MANDATORY BULLETIN Z 242L/11a

Z 142C/ 7a

1. **AFFECTED AIRCRAFT :** Z 242L aircraft S/N 541, 651-659
Z 142C aircraft S/N 556-559
2. **SUBJECT :** At the extreme deflection of the nose-wheel steering the screw of the Spring-mechanism L 242.4217 may interfere with the nose-wheel strut body.

- 10. APPENDICES :**
- Fig.No.1 - the spring mechanism before modification
 - Fig.No.2 - the spring mechanism after modification
 - New pages of the Z 142C Spare Parts Catalogue: 4-37/4-38, 4-39/4-40, 4-41/4-42, 4-43.

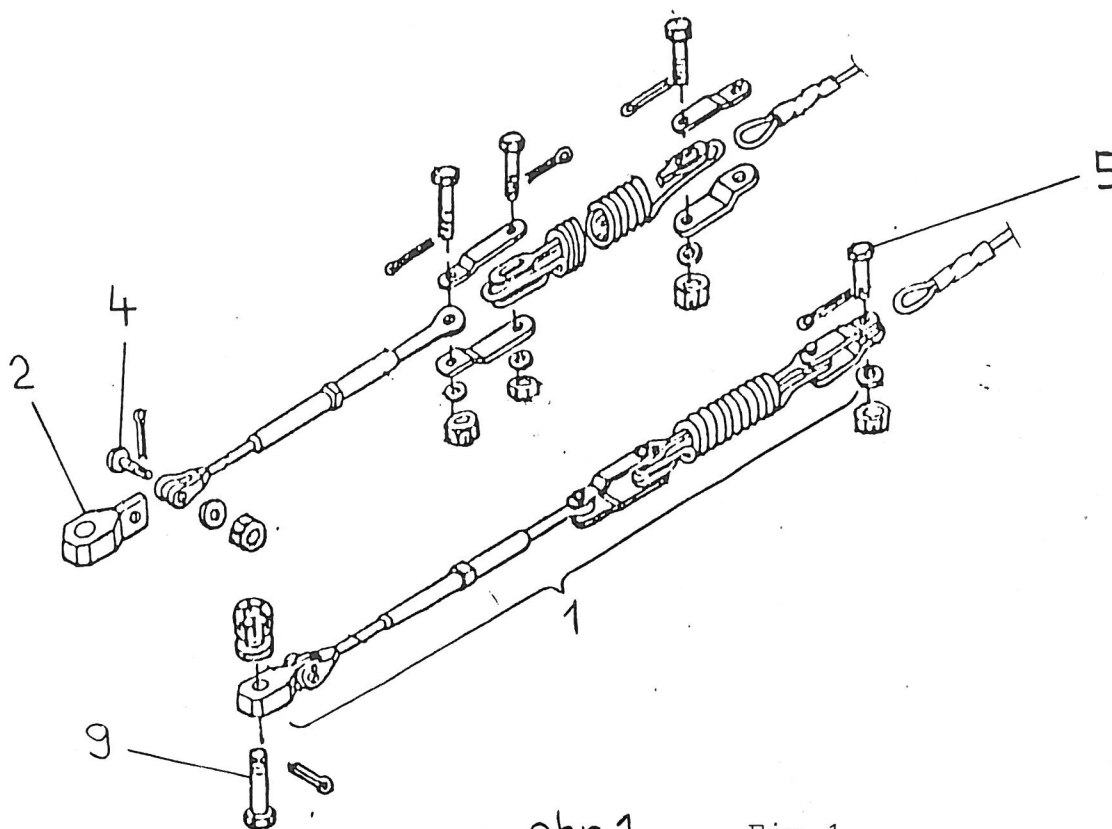
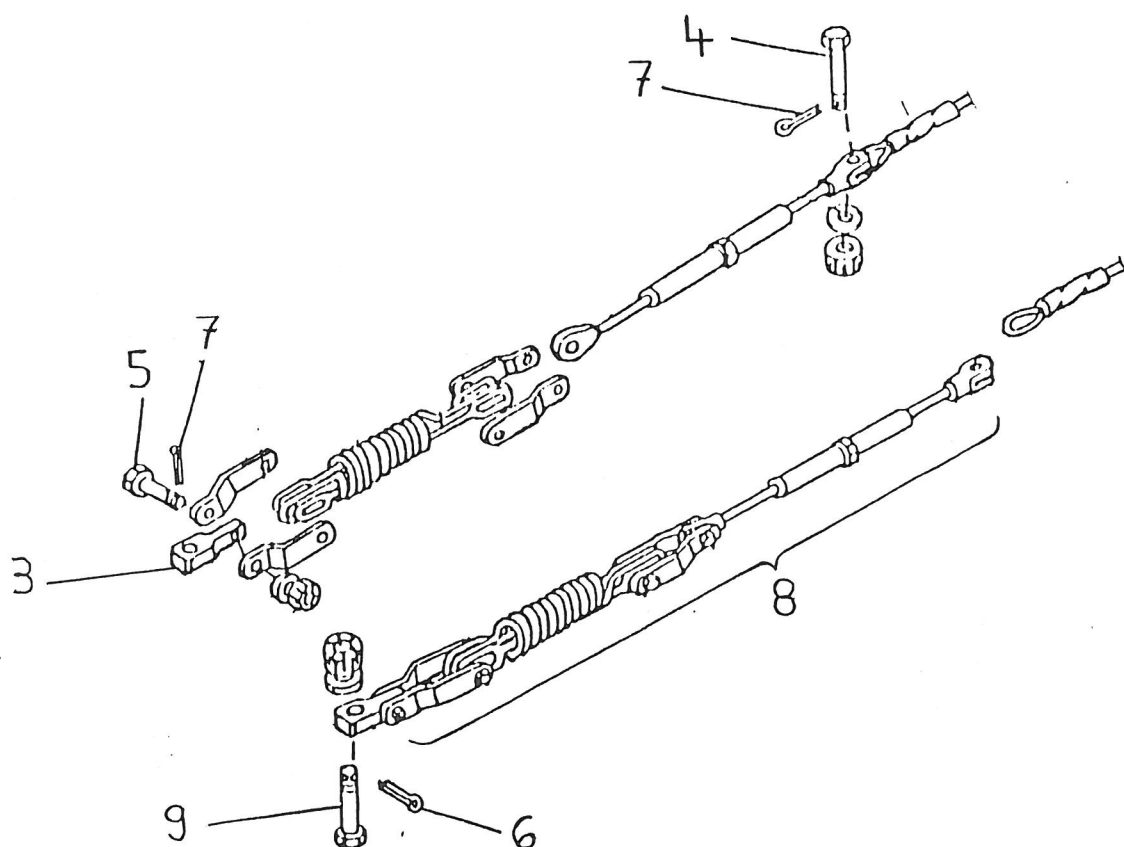
3. **CORRECTION :** Replace the cube Z 42.4217-00.03 by the cube L 242.4237-00.03 in the spring mechanism. Install the spring mechanism with its turnbuckle backwards.

- the Operator.
The material - the Manufacturer.
7. **PROCEDURE :**
 - a) Release the turnbuckle, remove the spring mechanism L 242.4217 (Item 1).
 - b) Remove the cube Z 42.4217-00.03 (Item 2).

- c) Install the cube (Item 3) between the shaped sheets (use the screw M5x16-Item 5, the new cotter pin - Item 7 from the delivered material).
 - d) Re-install the spring mechanism L 242.4237 (Item 8) (for attachment to the control cable use the screw M5x18 (Item 4), the new cotter pin /Item 7/); for attachment to the nose landing gear strut use the original screw (Item 9), the new cotter pin (Item 6) from the delivered material). Tighten the cube (Item 3) with the screw (Item 9), so that the cube moves on the screw (Item 9).

- e) Prestress the spring with the turnbuckle so that gaps between the spring coils 0,3-0,5 mm appear; then lock the turnbuckle with the binding wire. The rudder must be in the neutral position and the nose wheel parallel to the aircraft longitudinal axis during spring prestress adjustment.
